City of San Antonio

Re: **Southton Park**

UD/MDP # 002-07

The City Staff Development Review Committee has reviewed Southton Park Urban Development Plan/Master Development Plan (**UDP/MDP # 002-07**). Please find enclosed a signed copy for your files. Your plan was approved for acceptance, however please note the following:

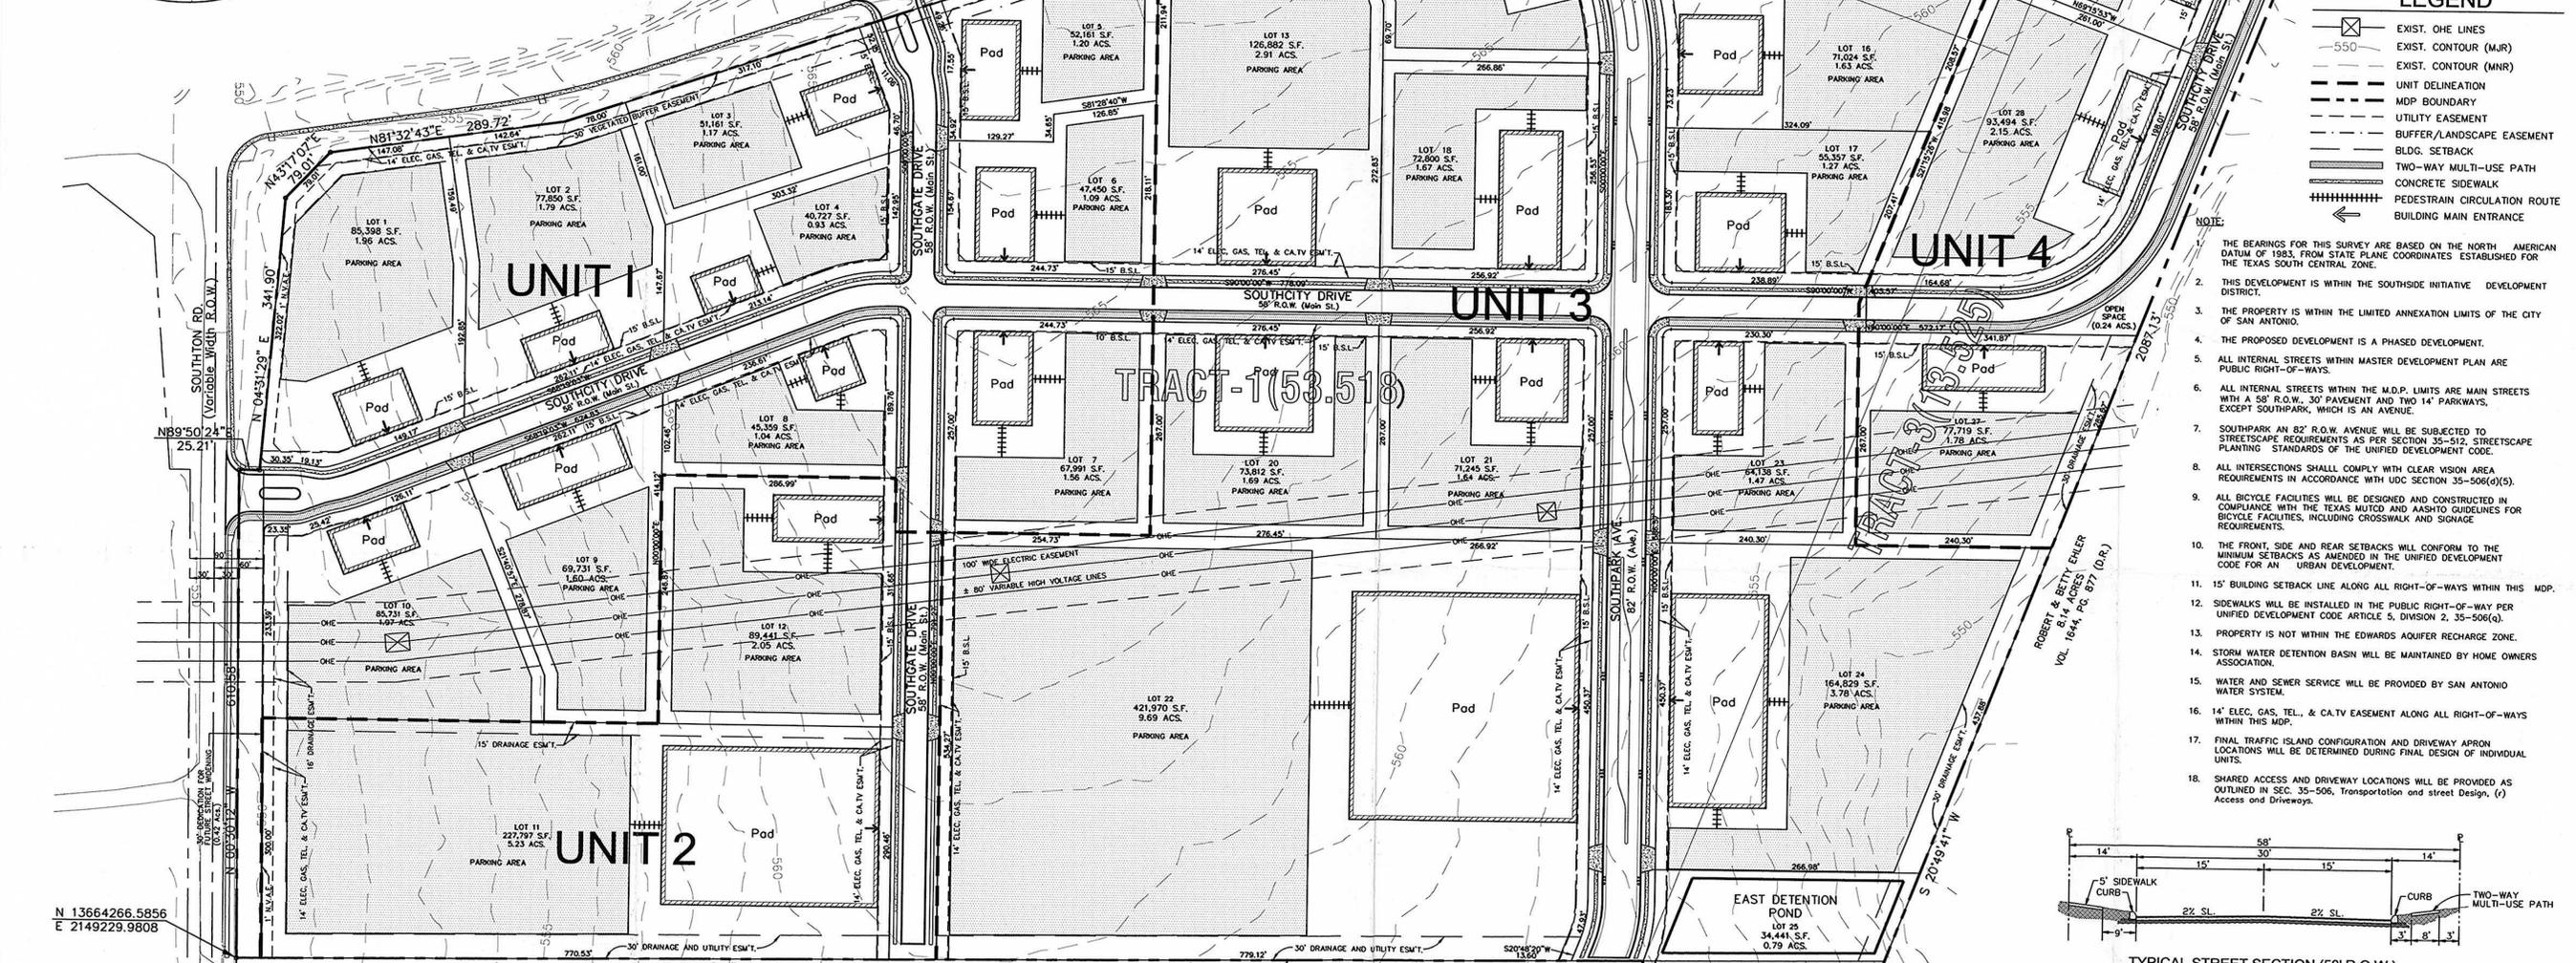
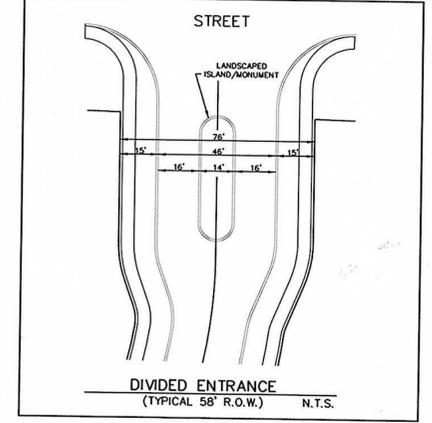
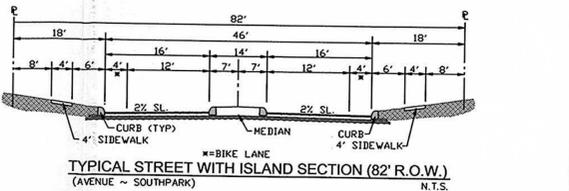
In consideration of public safety and convenience, excessive grades by reason of topography should be avoided in street layouts and arrangements. Any access and R.O.W. issues along state facilities will need to be resolved with the **Texas Department of Transportation (TXDOT)**. For information about these requirements you can contact TXDOT at 615-5814.

Historic Preservation: The Texas Sites Atlas indicates that no archaeological sites have been previously identified within the above referenced property. However, the project area is along the 550' contour of the San Antonio River, an elevation known to contain significant archaeological deposits. Therefore, there is a **high probability** that the property may contain sites, some of which may be significant.

DSD – Traffic Impact Analysis & Streets indicates the following on-site improvements, as well as, improvements along the project limits are necessary and shall be provided by the developer, on and before the completion of the development at no cost to the City of San Antonio:

- Driveway throat lengths shall comply with UDC 35-506, Table 506-7 requirements.
- All commercial driveways for this project shall comply with UDC 35-506, (r) Access and Driveways.
- All access driveways shall provide clear sight distance along all streets surrounding the development to provide adequate obstruction-free viewing distances for approaching

traffic. All signage, landscaping, and improvements shall be selected and located so as to not block these clear sight distance areas.

- Southton Road at Proposed Drive A. Provide a SB Southton Road left-turn lane and NB Southton Road right-turn lane for traffic entering Drive A.
- Eastbound IH-410 Frontage at Proposed Drive B. Provide EB IH-410 Frontage Road deceleration/right turn lane for traffic entering Drive B and a right turn/acceleration lane on Northbound Drive B.

- Eastbound IH-410 Frontage at Proposed Drive C. Provide acceleration/deceleration lane on Eastbound IH-410 and a right turn lane on Northbound Drive C., and an acceleration lane for traffic exiting Drive C.

- S. Presa Street at Drive D. Provide a SB Presa Street deceleration/ right-turn lane for traffic turning right into Drive D, a NB Presa Street deceleration/left-turn land for traffic turning left into Drive D, and a left turn lane for traffic turning right from Drive D into Presa.

- Incorporate traffic control improvements such as signing and pavement markings into the site plan that conform to the Texas Manual on Uniform Traffic Control Devices.

- The developer shall be responsible for providing right-turn deceleration/acceleration lanes and left turn lanes with storage lengths and bay taper in all street and driveway access point approved by TX DOT as it relates to the submitted TIA traffic counts, (Unified Development Code (UDC) - 35-502 (a)(7), subsection C.

Tree Preservation: This Master Development Plan meets the criteria of the 2006 Tree Preservation ordinance (Section 35-B125 and Table 35-B101) and is approved.

- 2006 Tree Preservation ordinance standards per UDC Section 35-523 – a Tree Preservation Plan is required prior to any work on site. This can be submitted either as a site work permit or at the platting stage.
- Landscape ordinance per UDC Section 35-511. It appears some landscape points can be met by preserving existing vegetation as well as contributing to mitigation requirements (either through preservation of smaller material or transplanting). Recommend securing knowledgeable Landscape Architect at planning and design phase to better utilize existing trees and vegetation. Preservation will eliminate the need for irrigation.
- Staff would be willing to meet with developer at design stage to assist with tree preservation and landscape plan.

- Streetscape standards per UDC Section 35-512 – Southpark Ave. requires streetscape on the new ROW (recommend preservation of existing trees where available and possible).

It will be expected that you will plat all of the property depicted in your Urban Development Plan/Master Development Plan (UDP/MDP) to include floodplains, drainage areas and open spaces.
